SERVICE BULLETIN 13-3-21 REV 1

Subject: Ethanol in gasoline

Affected Models: All flying RV-12 and RV-12iS aircraft

FIGURE 1: WD-1221 CRACK LOCATIONS

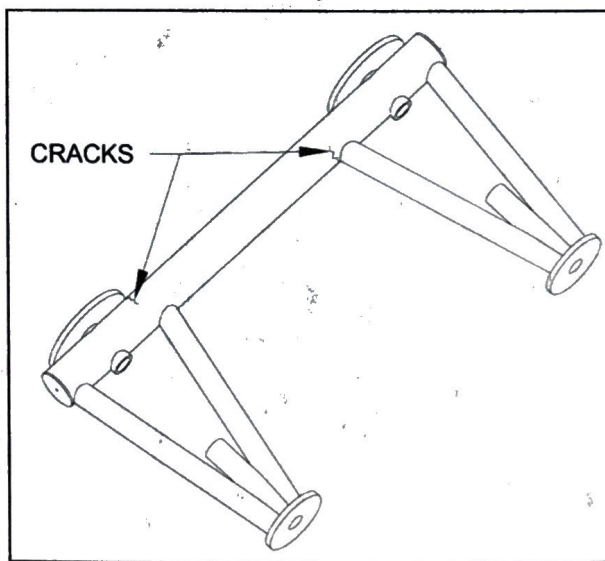
Remove the top cowl. Inspect the WD-1221 Engine Mount Standoff for cracks in the main cross tube (refer to Figure 1 for specific location).

If cracks are discovered in the standoff, notify Van's Aircraft support at support@vansaircraft.com and replace it with a WD-01221-1 Engine Mount Standoff as described in this document. If no cracks are discovered, 100-hour inspections are required until the standoff is replaced.
